City of Alexandria, Virginia

MEMORANDUM

SUBJECT: 3rd CONCEPT REVIEW OF 1101 NORTH WASHINGTON STREET
(BEST WESTERN OLD COLONY INN)
BAR CASE # 2015-0156

CC NORTH ELEVATION - SUBMITTED SEPTEMBER 21, 2015 (CURRENT)
3/32" = 1'-0"

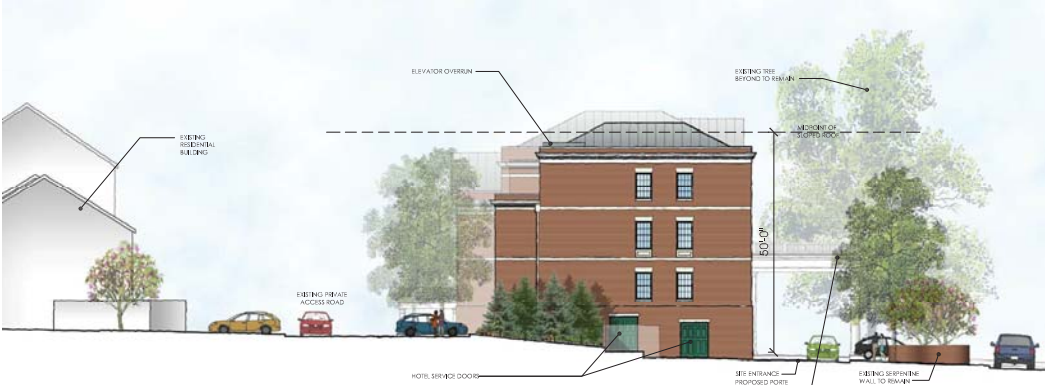
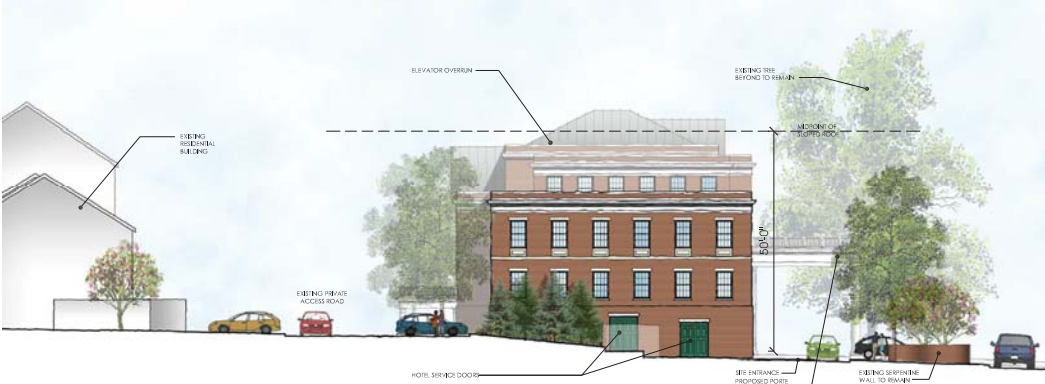
Staff believes that the three story “Current Alternative” south elevation (sheet A2.5) has been dumbed down and does not successfully address the much larger four story condo buildings across the street to the south or present an appropriate building terminus when viewed driving north on East Abingdon. While many of the commercial buildings in this area and mews-style townhouses in North Old Town turn their backs to the street, the BAR’s *Design Guidelines* generally encourage projects that promote the pedestrian experience and enhance the streetscape. Staff believes that the Second Street elevation, utilizing a pedimented, symmetrical façade shown in the second BAR concept review of August 5, 2015 should be utilized. This recommendation permits a visual dialogue between the pediments of the central mass and the south end that creates a more unified whole. Because of the one way service streets and generous landscaping, the north elevation of the building will not be as visible from the Parkway and symmetry is not as important here.

- *Continue to refine the north and south elevations.* Because the recommended scheme includes different versions for the front and rear elevations, the applicant should continue to refine these elevations so that the building reads as a clear entity, particularly on the south elevation which is substantially more visible from a public way.
- *Show location and type of signs proposed.* As this building will be so well-detailed and the architecture itself will convey its use, the signs must be carefully placed and consistent with the architectural style.
